REMARKS

Claims 1-23 are all the claims pending in the application. New claims 14-23 have been added as a copy of the claims from US Patent 6,290,147, for the purposes of eventually provoking an interference therewith. Reconsideration and allowance of all the claims are respectfully requested in view of the following remarks.

Fig. 1

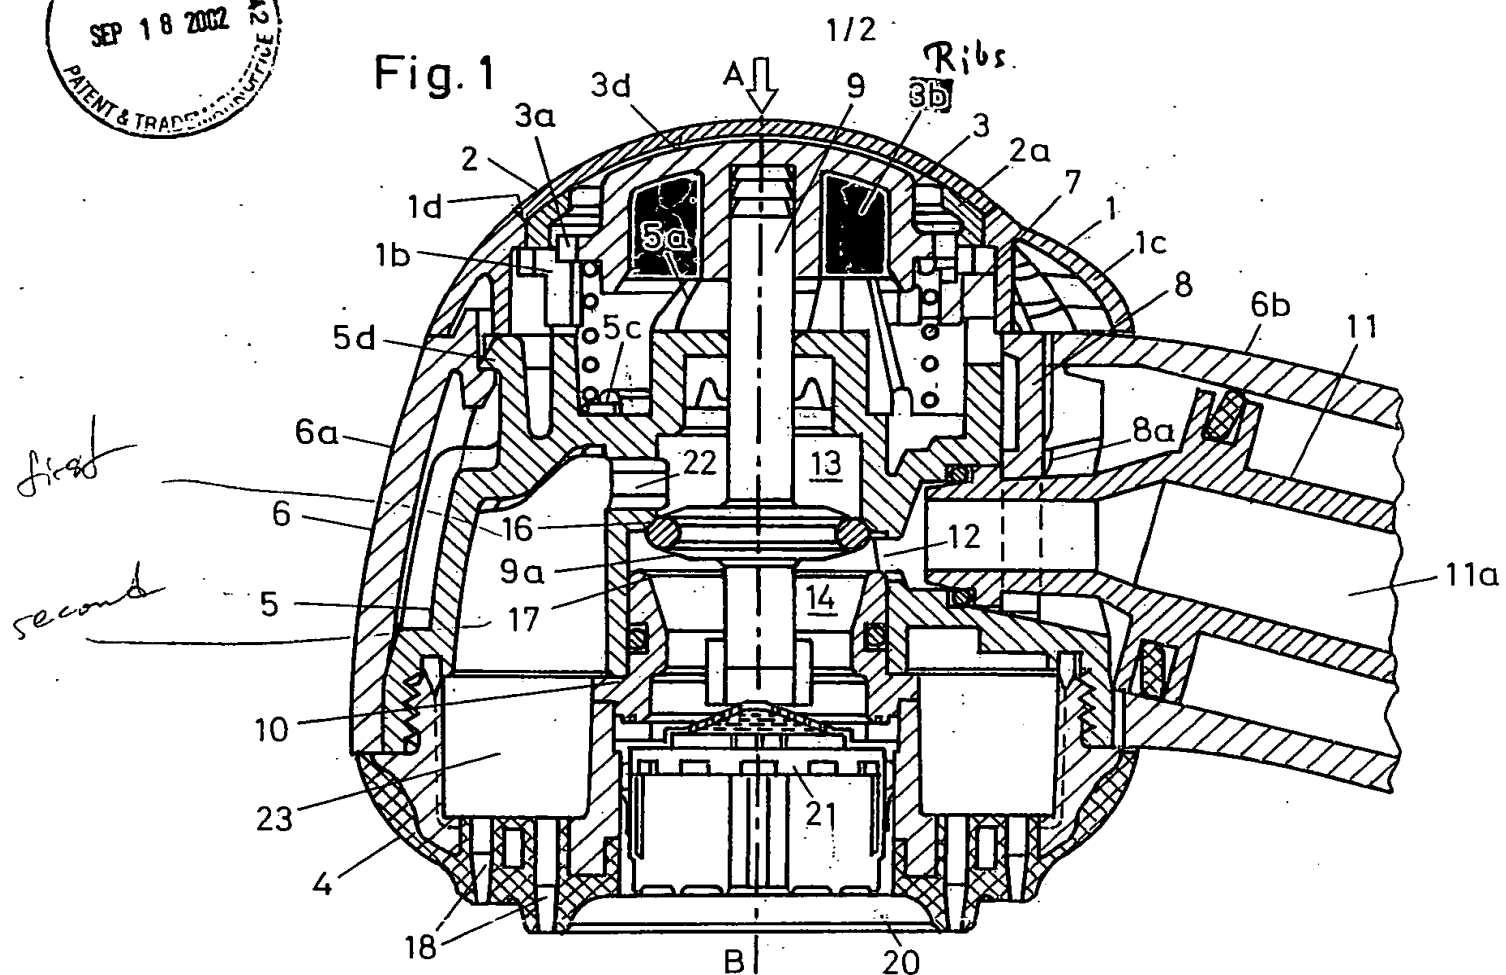
- The Examiner objected to the drawings as including certain reference signs not mentioned in the specification. Accordingly, Applicant has amended the specification to include the noted reference signs "1a", "5b", and "3c". No new matter has been entered.
- Further, the Examiner objected to the drawings as not showing every feature of the invention specified in the claims. Specifically, the Examiner asserted that "the 'reset mechanism' (two ribs 3b and the guide curves 5a and stop cam 5f) recited in claims 1, 8, [and] 9" must be shown. Applicants respectfully traverse this objection because the reset mechanism is, indeed, shown in the figures.

The ribs 3b and guide curves 5a are shown in Figs. 1-3, whereas the stop cam 5f is shown in Fig. 2. For the Examiner's convenience, submitted herewith is a copy of Figs. 1-3 wherein the ribs 3b are highlighted in blue, the guide curves 5a are highlighted with yellow, and the stop cam 5f is highlighted in pink.¹ The function of these elements is disclosed on page 5, lines 12-15, for example. When the button 3 is rotated, the ribs 3b are pressed to the guide curves and the button

3 is moved upwards. The spring 7 supports this upward movement. Thus, the drawings clearly show the reset mechanism, including the parts noted by the Examiner.
